CITY OF LINCOLN NEBRASKA

INDIVIDUAL SEWAGE SYSTEM CONSTRUCTION — October 12, 1979

FORM HD-41(73) APPLICATION FOR PERMIT TO ALTER, EXTEND OR REPAIR INDIVIDUAL SEWAGE DISPOSAL SYSTEM

ORIGINAL LOAN APPROVAL FILE
PREVIOUS HISTORY UNKNOWN

FG.4120 INDIVIDUAL SEWAGE SYSTEMS - County Resolution #2832

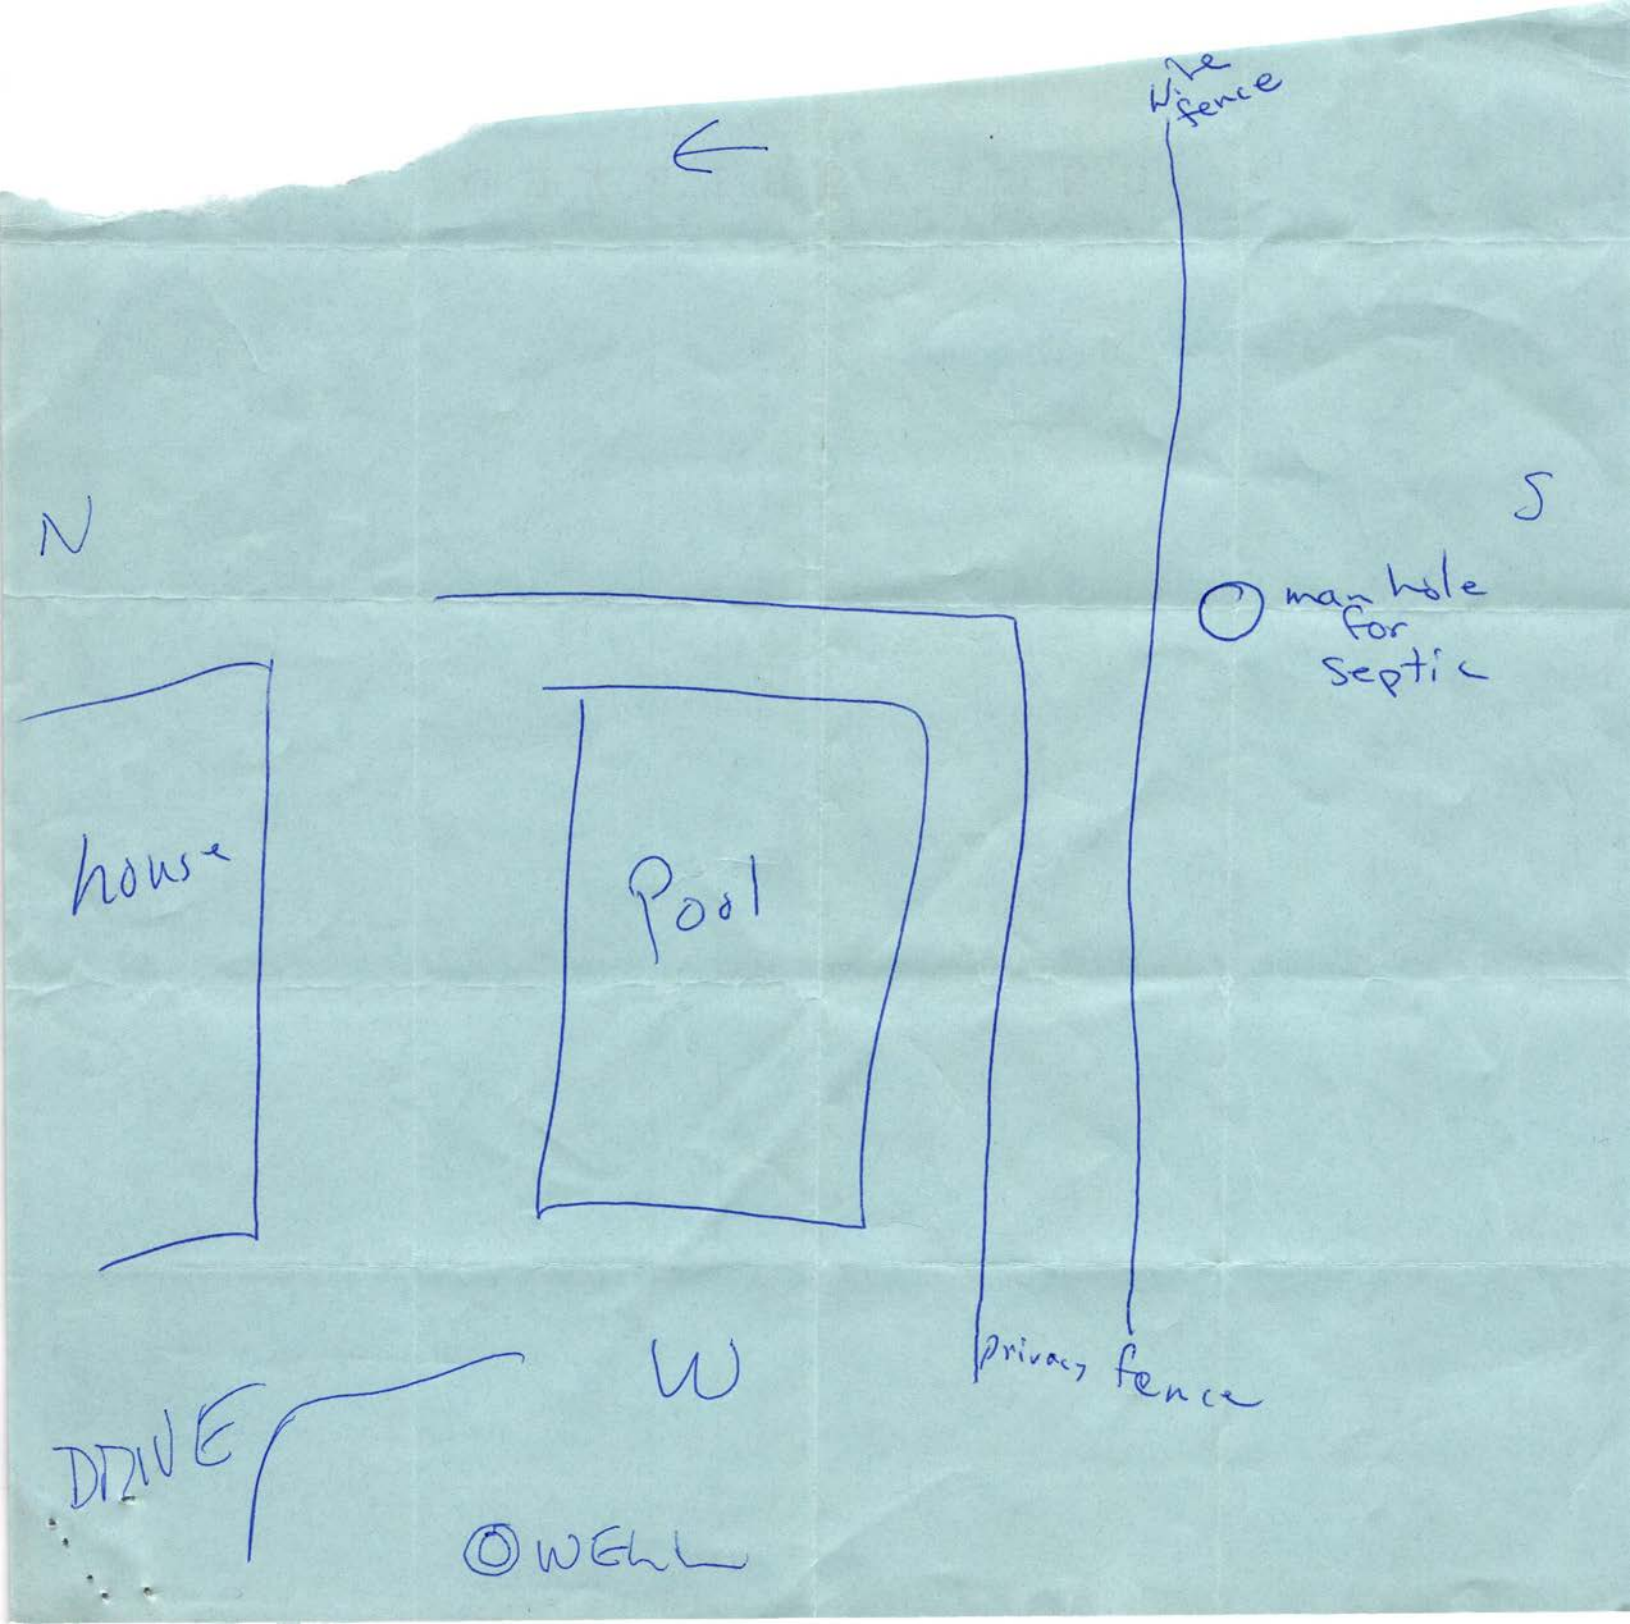
Comments: Recommend checking to see if septic tank needs pumping. Access cover to septic tank should be more secure - could be a safety hazard to kids. Original installation predates regulations, but repair permit work was done in 1979. Thus, a provisional approval ☐ See Attached Letter
